**GENERAL DYNAMICS**

Inter-Office Memo

TO: R. G. Hill  
XC: J. Brummans, T. Offer, J. Ruma  
SUBJECT: Water Ingestion - Mississippi National Guard  
REFERENCE: RGH/86-356 Correspondence Dated 01 July 1986  
ENCLOSURES: (1) Trip Report  
(2) Engineering Work Directive

GENERAL DYNAMICS  
LAND SYSTEMS DIVISION  
TRIP REPORT

FIG 3

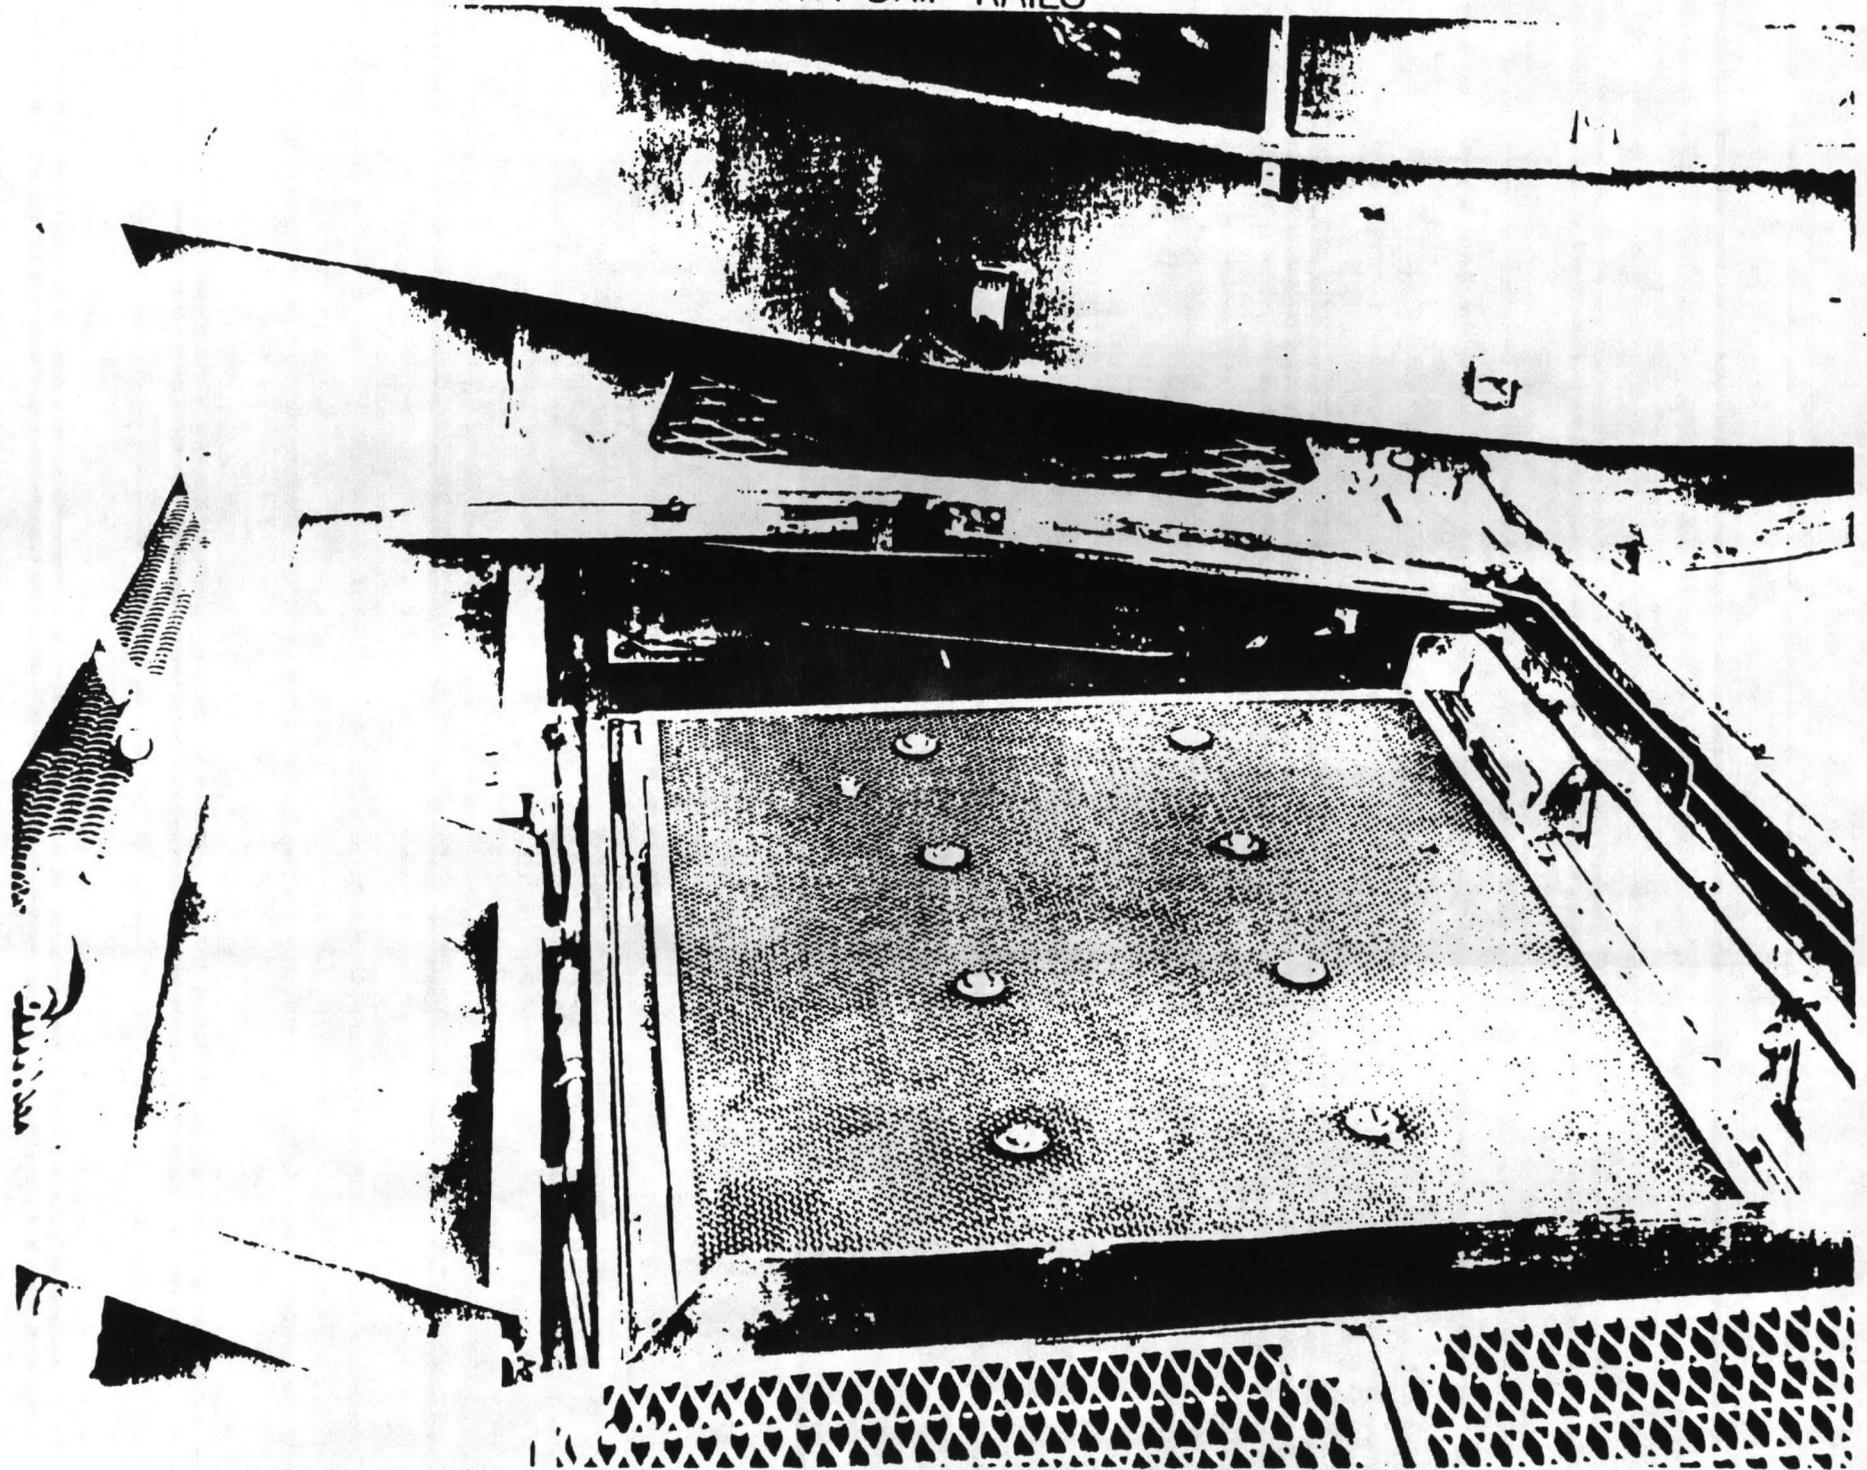
ECP GDLL 3626 has released a change to incorporate drip rails to alleviate air induction water ingestion. Reported incidents of water ingestion from Fort Hood, Fort Puke, APG and Europe were the reason for the drip rail ECP. A vehicle at GDLS engineering facility was modded with drip rails and successfully tested in the prototype shop with both Donaldson and PLM precleaners. A modded vehicle underwent a salt fog and field test at Eglin Air Force Base in Florida with a Donaldson precleaner. None of the Camp Shelby vehicles has been modded with the drip rails. When site personnel were shown photographs of the drip rails installed on a vehicle, all indicated that the rails would reduce water ingestion, but some were uncertain that the mod would be sufficient to eliminate it.
